SUBJECT: Forwards "Rept on Exploration/Demobilization of Wells 4 & 5"
 by Woodward Clyde & "Rept on Deep Exploration Drilling
 Program, Dewatering Well 7" & "Rept on Exploration/Grouting
 Program, Dewatering Well 7" (2 vols), by Bechtel.

Subject: Docket Nos. 50-361 and 50-362
San Onofre Nuclear Generating Station
Units 2 and 3

ERRATA FOR REPORT ON
DEEP EXPLORATION DRILLING PROGRAM DEWATERING WELL NO. 6
FEBRUARY 1979

ERRATA FOR REPORT ON
SHALLOW EXPLORATION/GROUT PROGRAM DEWATERING WELL NO. 8
AUGUST 1978

BECHTEL POWER CORPORATION ENGINEERS & CONSTRUCTORS LOS ANGELES, CALIF.			J.O. NO.	SAN ONOFRE NUCLEAR GENERATING STATION
FIGURE 8				ISOMETRIC DRAWING OF CAVITY
JOB NO. 10079-003	DATE AUG. 1978	APPROVED <i>A. Arnold</i>		SOUTHERN CALIFORNIA EDISON COMPANY SCALE N.T.S. LOS ANGELES, CALIF.

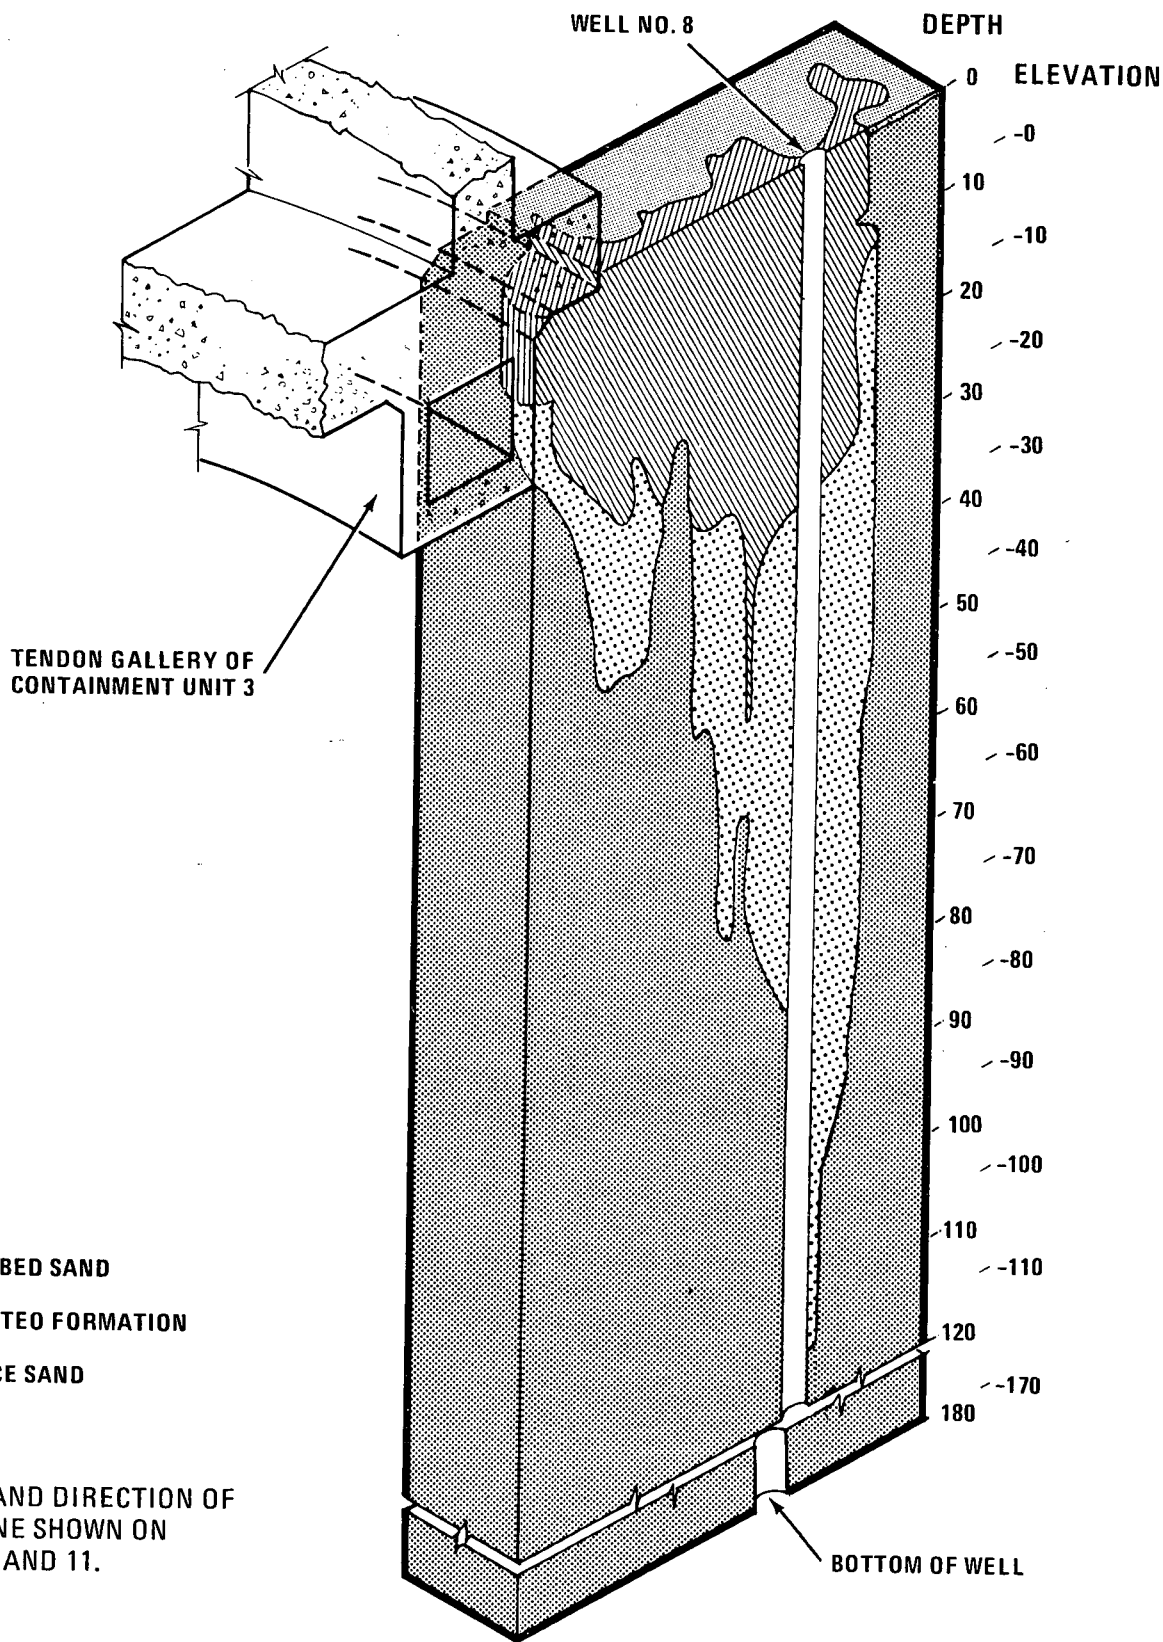
This figure, Isometric Drawing of Cavity, has been revised to show the lower extent of disturbed sand at a depth of 115 feet (Elevation -85 feet).

J.O. NO.	SAN ONOFRE NUCLEAR GENERATING STATION
FILE	SHALLOW EXPLORATION
SHEET No. 11	GROUTING PROGRAM - WELL No. 8
OF 12	APPENDIX B
	GRAPHIC LOGS
	SOUTHERN CALIFORNIA Edison COMPANY
	SCALE N.T.S. LOS ANGELES, CALIF.

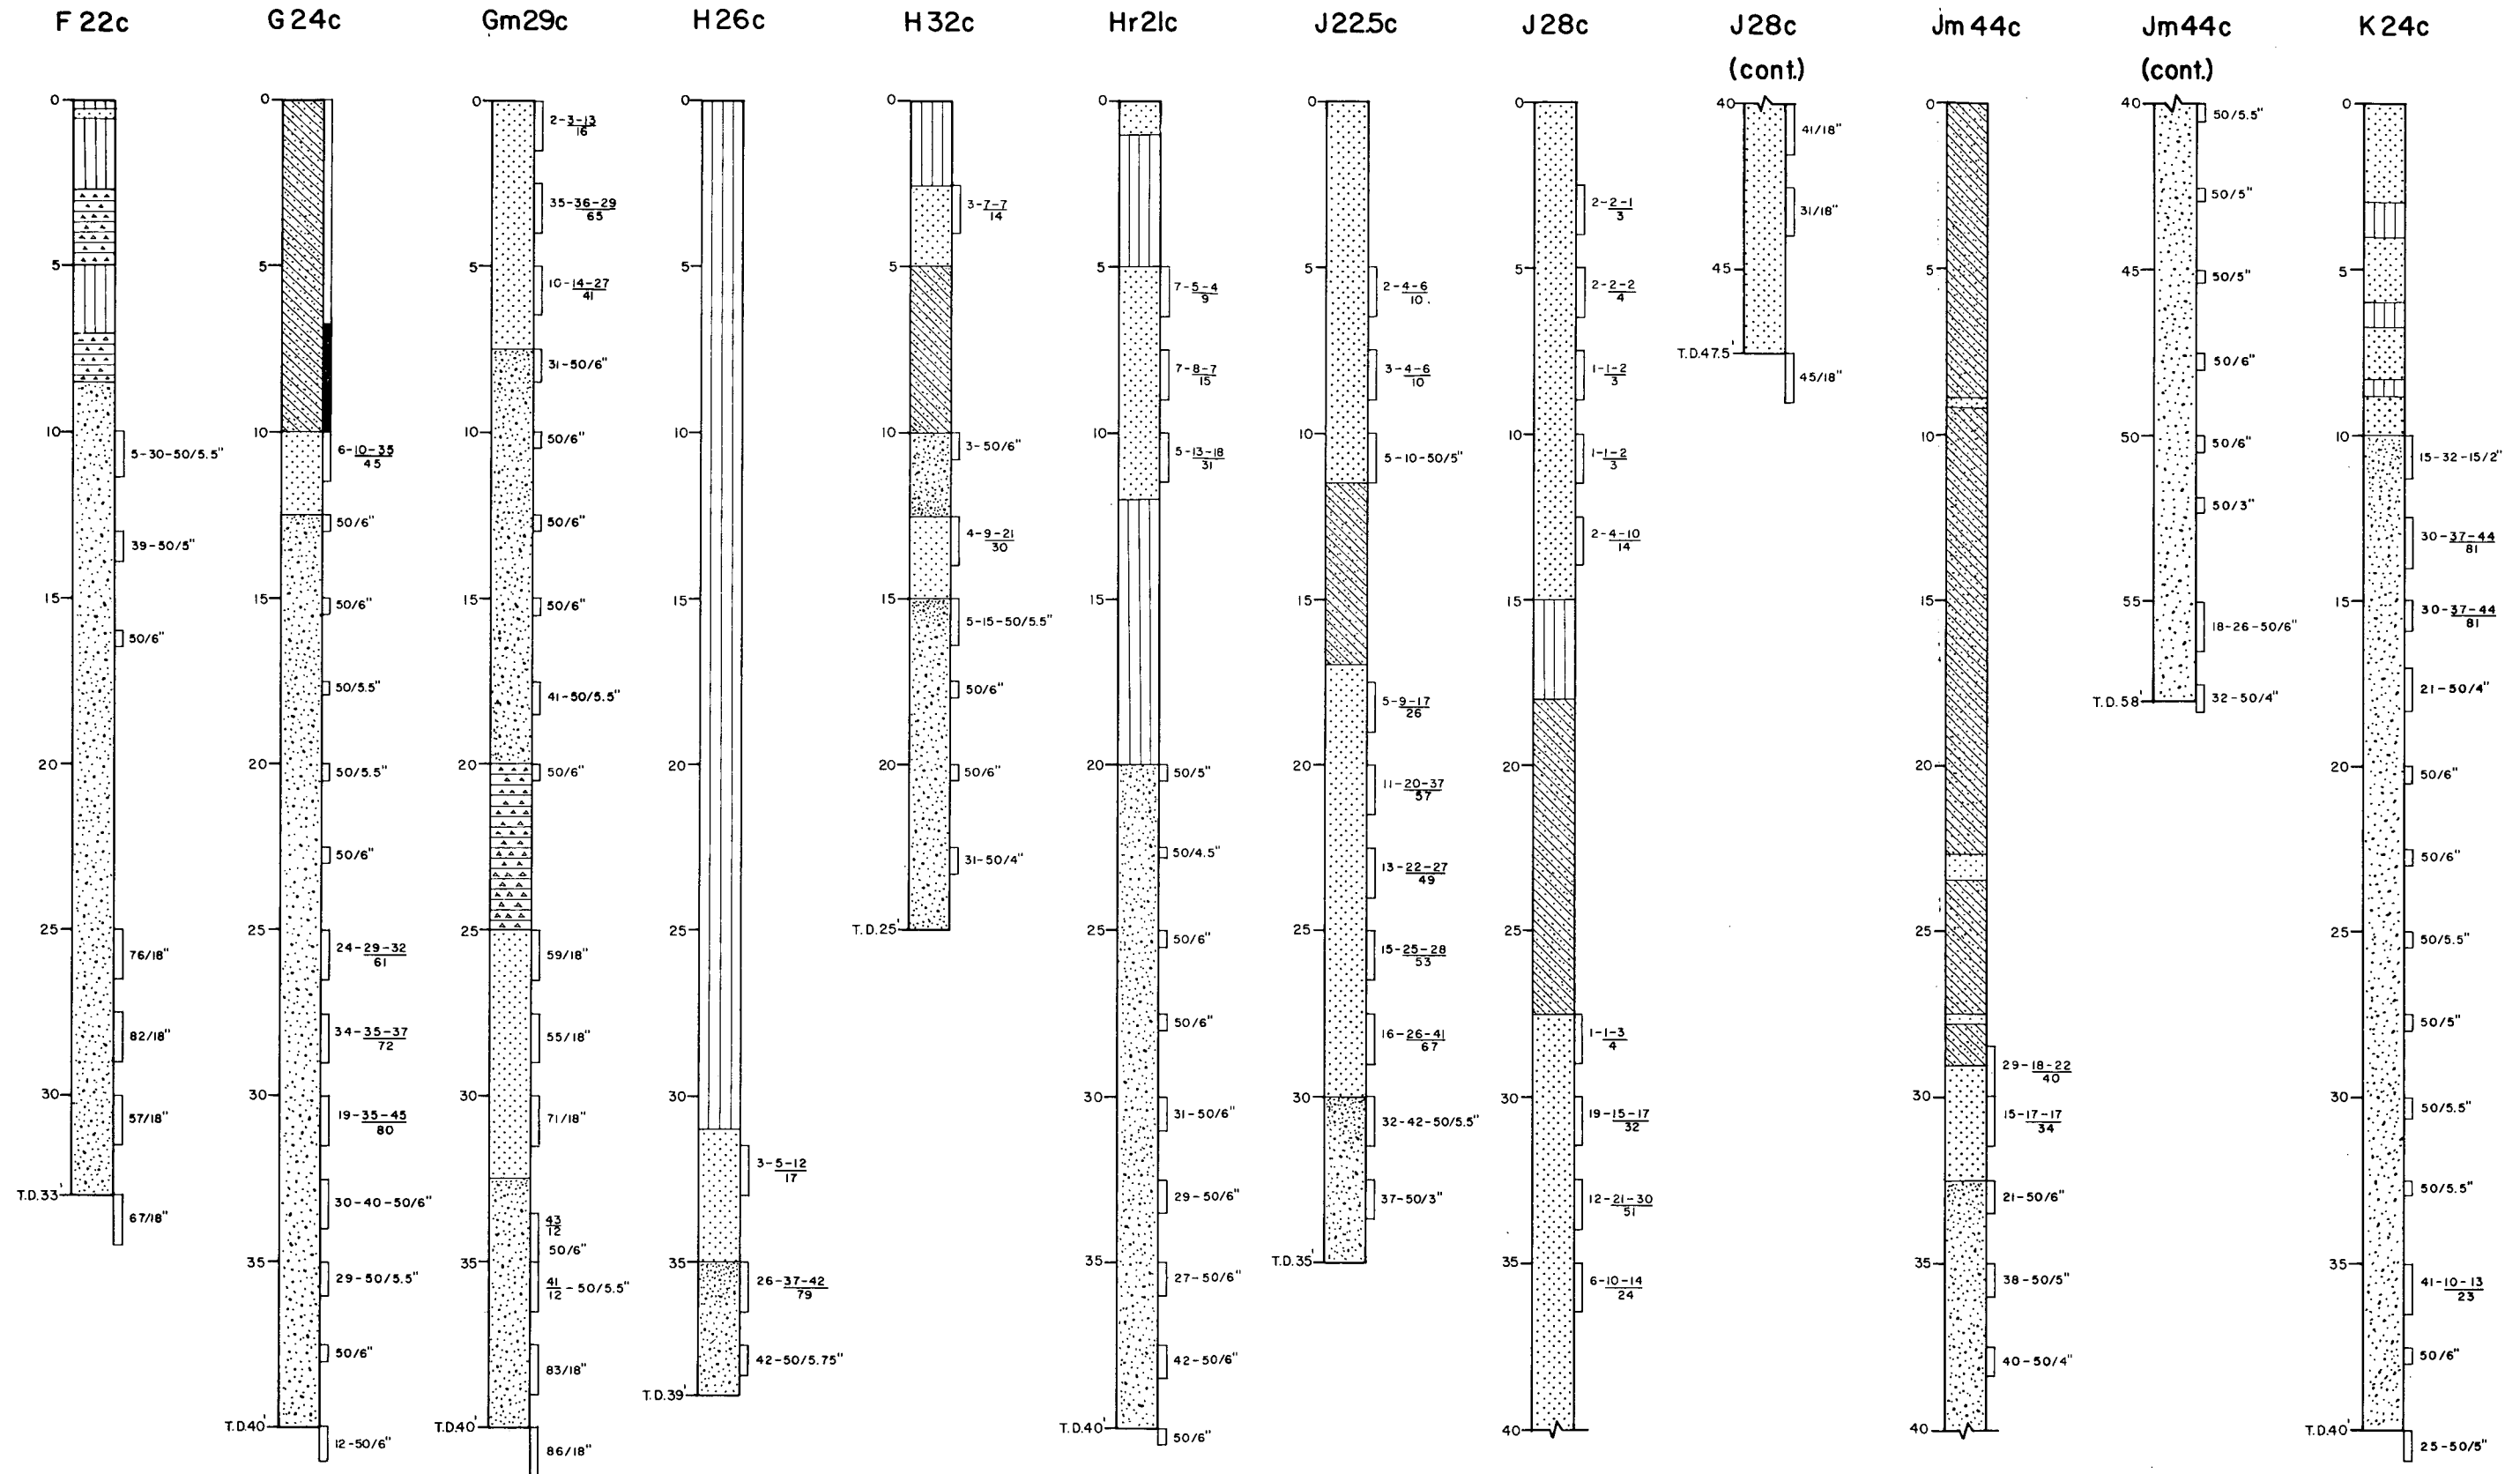
Sheet 11 of 12 Graphic Logs. The graphic log of drill hole G24c has been revised to show the blow counts of the Standard Penetration Test at 40 feet. The blow counts should read "12-50/6" for a 12-inch penetration.
